SUPPLEMENTAL CORRECTION SHEET FOR THE BASELINE HILLSIDE ORDINANCE (BHO)
 (Ordinance No. 184,802 Effective 3/17/17)

This is a supplemental correction sheet. Please see the attached master correction sheet.

These corrections apply to new construction, additions, and major remodels to any Building or Structure on a lot in the R1, RS, RE, or RA Zones and in a designated Hillside Zoning Area (12.21C.10.):

Figure 12.21 C.10(a): Plane break diagram

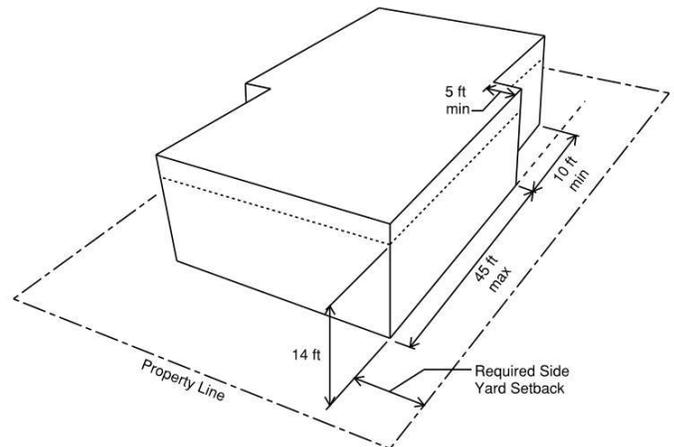
3. In the R1 zone, where the Building or Structure has a side wall that exceeds a height of 14 ft. and has a length of 45 ft. or more, provide an offset/plane break that has a minimum depth of 5 ft., beyond the required Side Yard setback, for a minimum length of 10 ft. (*Table 12.21C.10-1*). See below for Example Figure 12.21 C.10(a).
4. In the R1 zone, any occupied rooftop deck shall be set back at least 3 ft. from the minimum required Side Yard setback. This does not apply to any rooftop deck located on the street side of a corner lot. *12.21C.10(a)(7)*

Figure 12.03-1: Encroachment Plane diagram

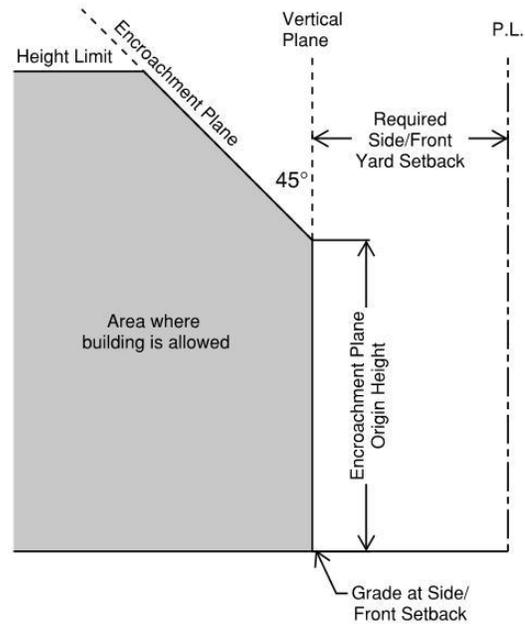
5. Show that all Buildings and Structures in the R1 zone do not exceed the Encroachment Plane Height with an Encroachment Plane Origin Height of 20 ft. and Encroachment Plane angle of 45° measured from existing or finished grade whichever is lower. See Figure 12.03-1 to the right.
